**LEE'S SUMMIT**  
**MISSOURI**  
Development Services Department

## Development Services Staff Report

<b>File Number</b>	PL2022-192 - REZONING from RP-2 to CBD and PRELIMINARY DEVELOPMENT PLAN - Ellis Glen
<b>Applicant</b>	MKEC Engineering, applicant
<b>Location</b>	102-110 SW Market St.
<b>Planning Commission Date</b>	August 25, 2022
<b>Heard by</b>	Planning Commission and City Council
<b>Analyst</b>	C. Shannon McGuire, Planner
<b>Checked By</b>	Hector Soto, Jr., AICP, Senior Planner Kent Monter, PE, Development Engineering Manager

Figure 1

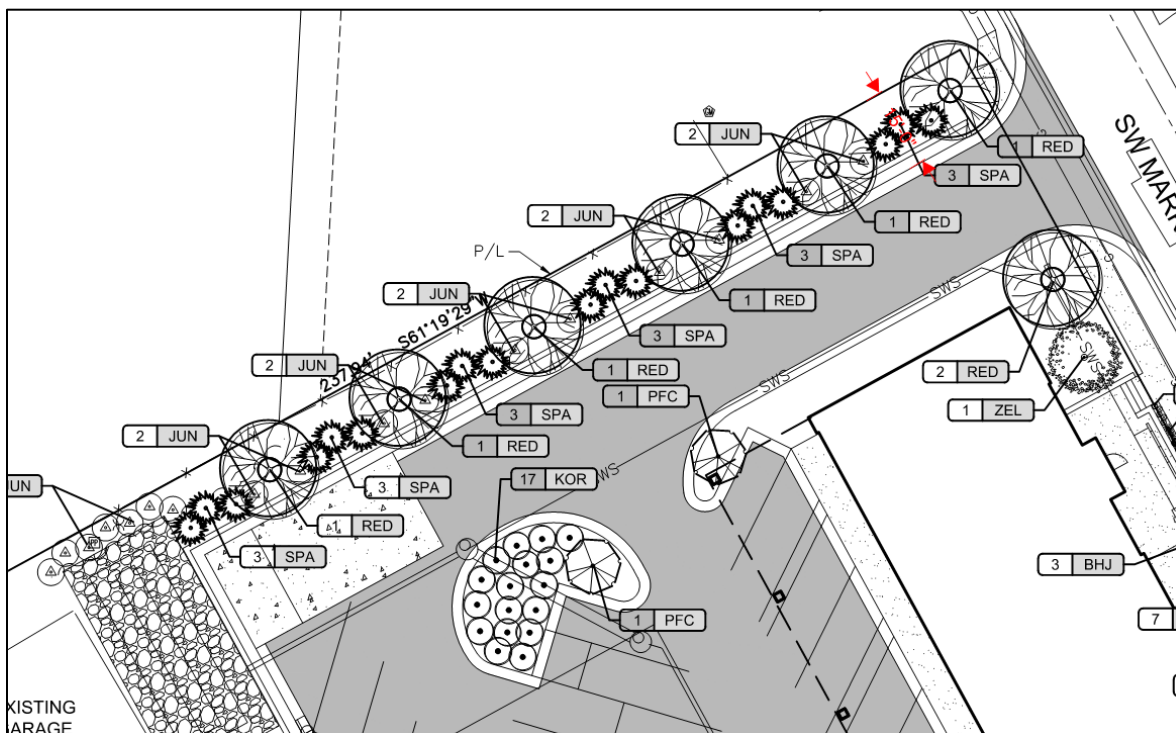
- **Required** - The UDO requires parking lots to be set back a minimum 20' from any residential district or use.
- **Proposed** - The applicant proposes to reduce the required parking lot setback from 20' to 15' along the north property line (Figure 1) and 13' 8" adjacent to the south property line (Figure 2).
- **Recommended** – Staff supports the requested modification. The reduced setback is a result of the applicant's desire to maximize the available parking on the site. The encroachment is limited to drive aisles with all parking stalls meeting the setback requirements. The applicant has proposed to install additional landscaping adjacent to the areas of encroachment. For these reasons staff feels the request is reasonable.

1. A modification shall be granted to reduce the required parking lot setback from 20' to 15' along the north property line and 13' 8" along the south property line.
